**SHOP DRAWINGS
FOR
STANDARD CABINETS**

COLLEGE OF SAN MATEO (BLDG 17)

PANKOW SPECIAL PROJECTS, L.P.

*SHOP DRAWINGS PREPARED FROM
ARCHITECTURAL DRAWINGS DATED 5/15/2009*

56

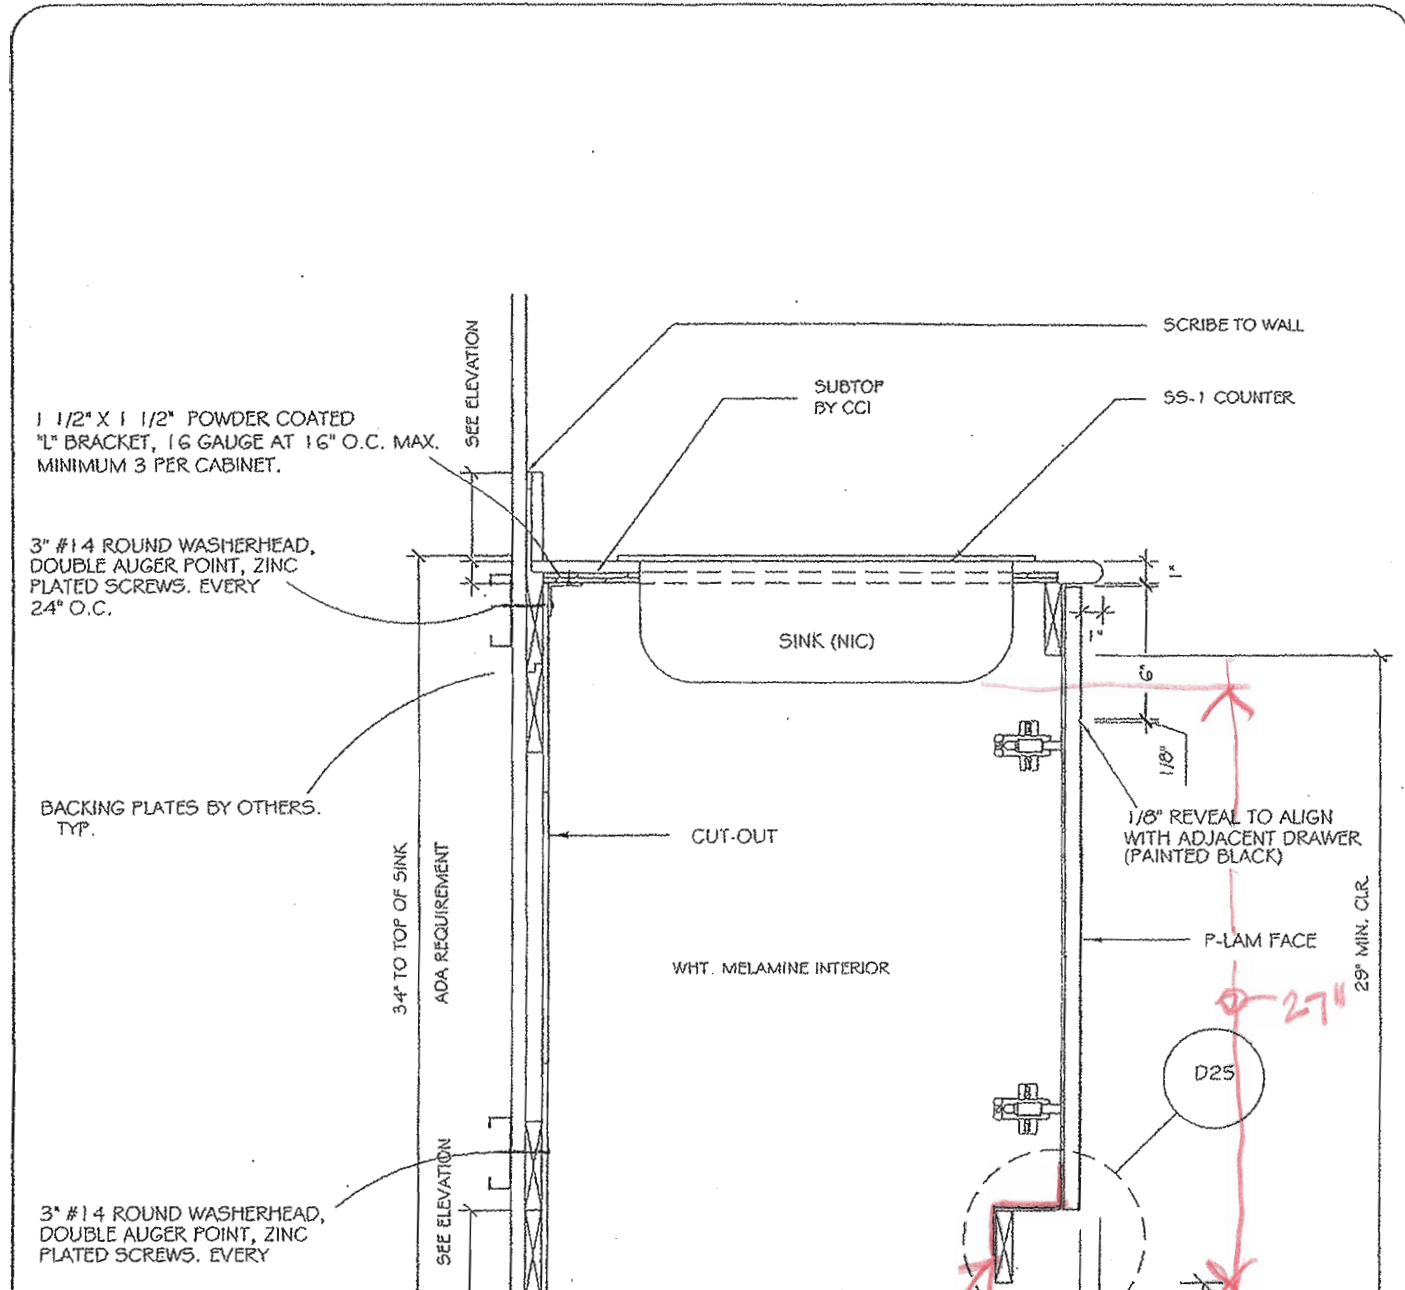
*STU. PLATE
NOT ALUM.*

*SAME COMMENTS
AS '52'*

57

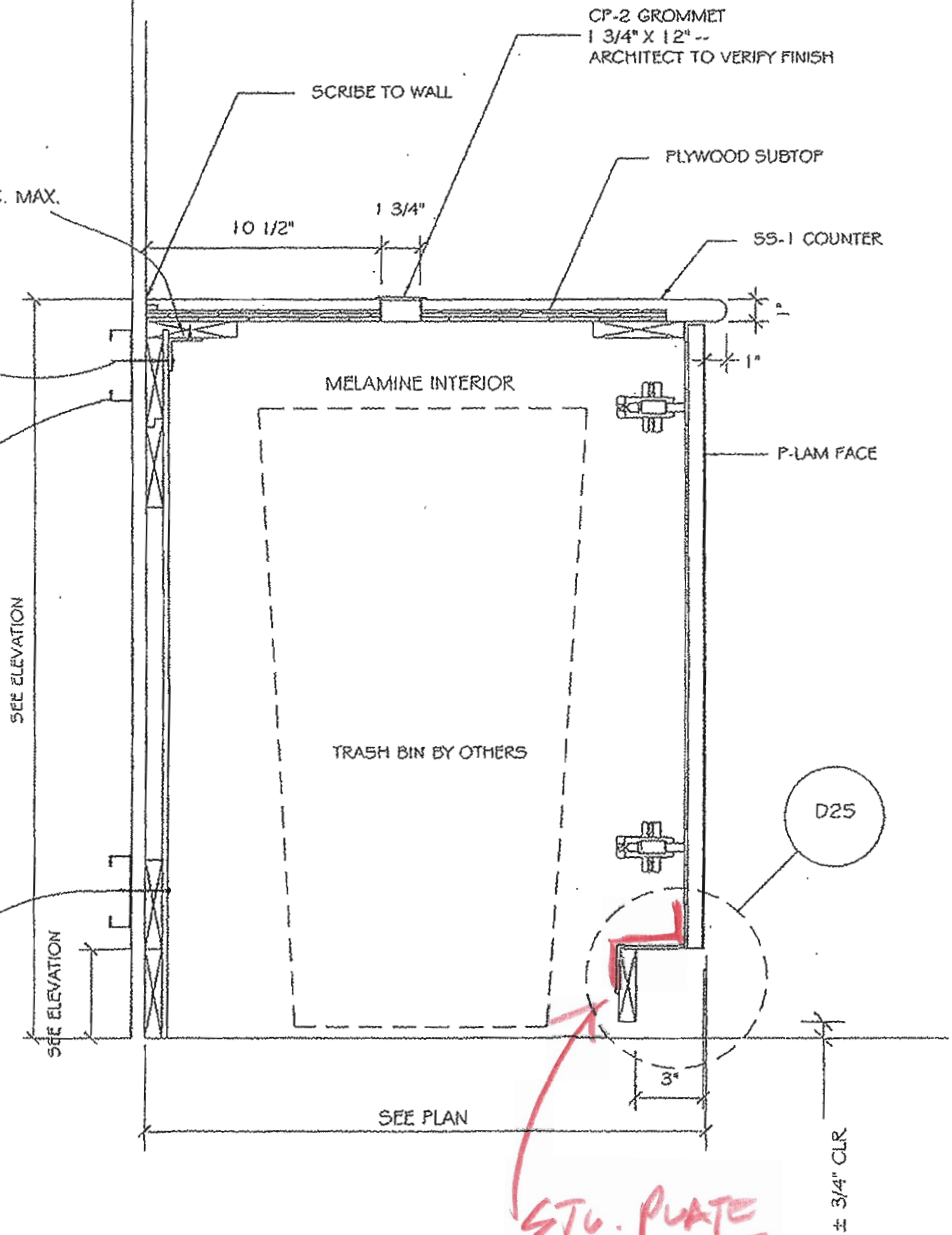
WHERE DOES THIS
DETAIL APPLY

STG. PLATE
INSTEAD OF
ALUM. SEE 52'

58

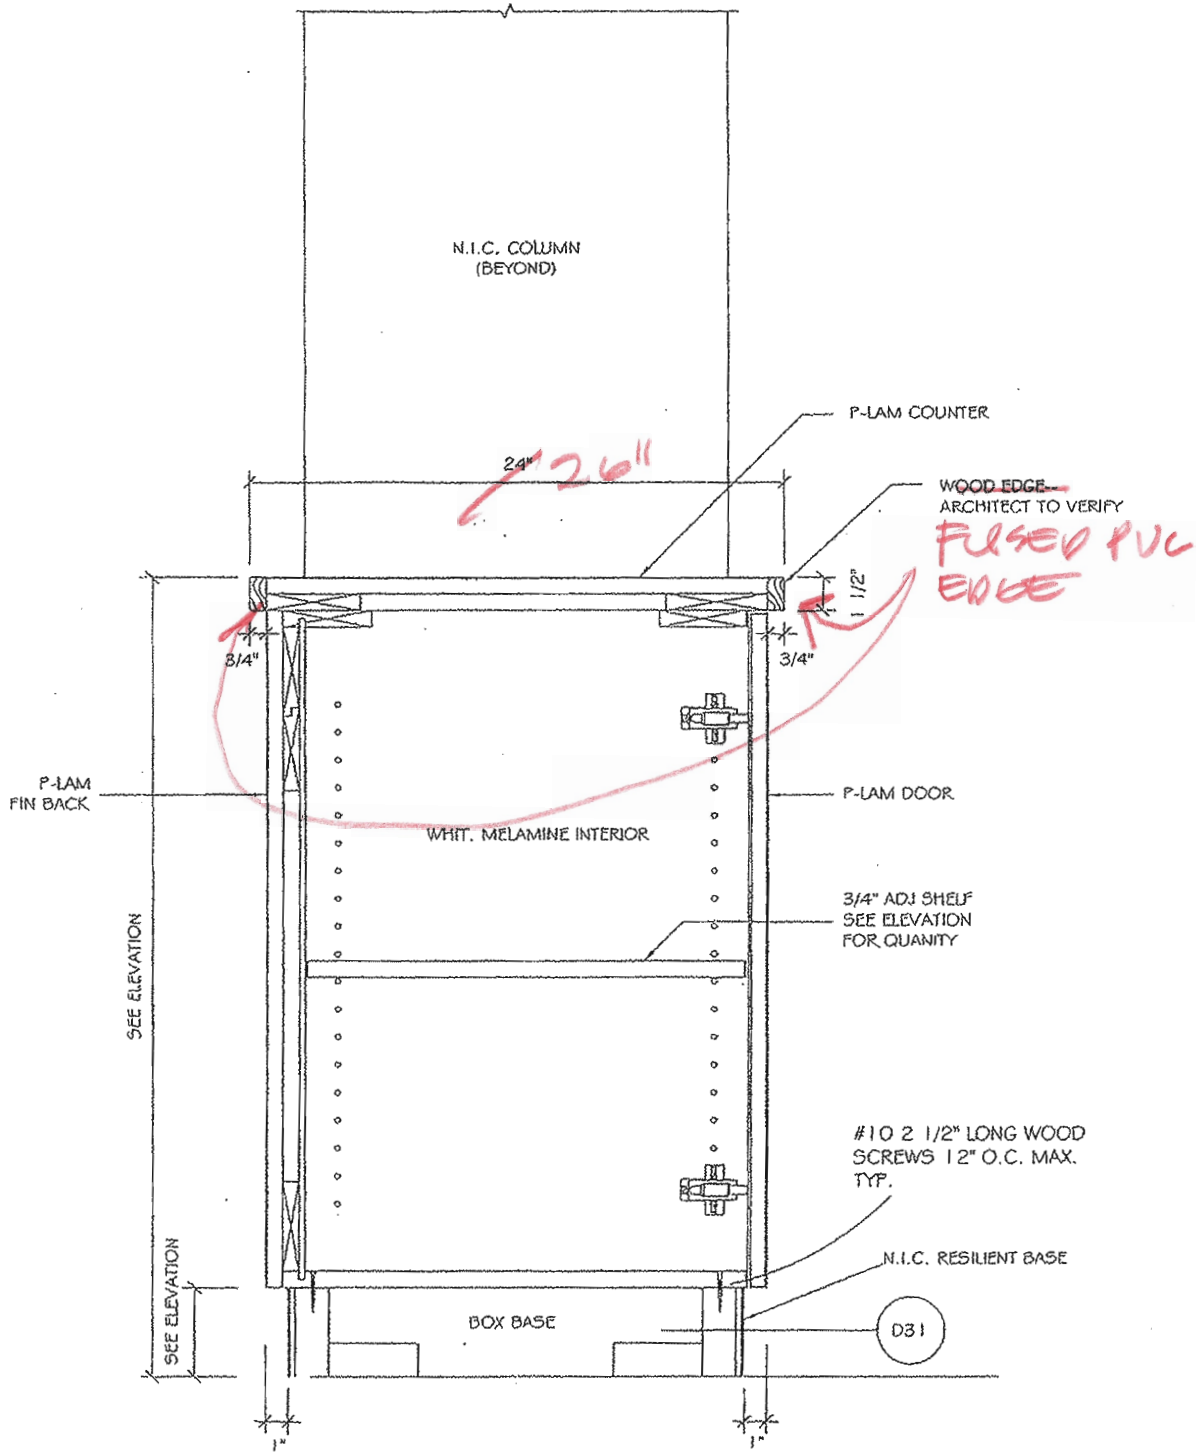
WOOD EDGE
ARCHITECT TO VERIFY
**FUSED PVC
EDGE**

24" **26"**

SEE '52'

59

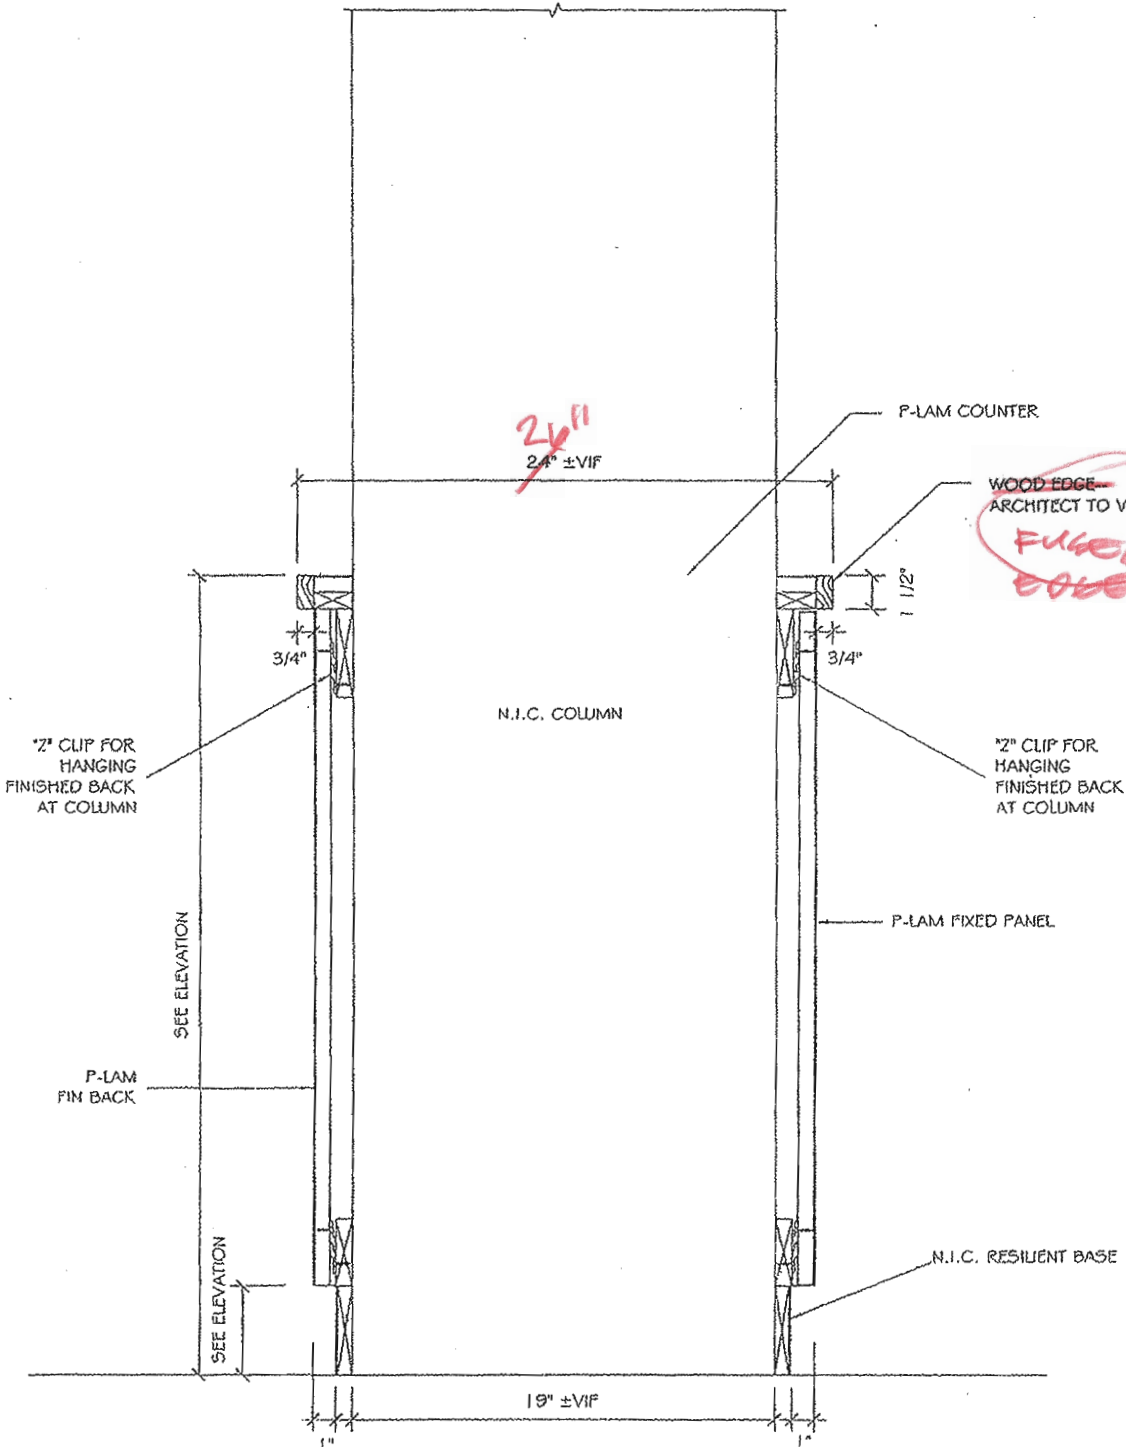
~~24"~~
24" ±VIF

WOOD EDGE
ARCHITECT TO VERIFY
Fused PVC
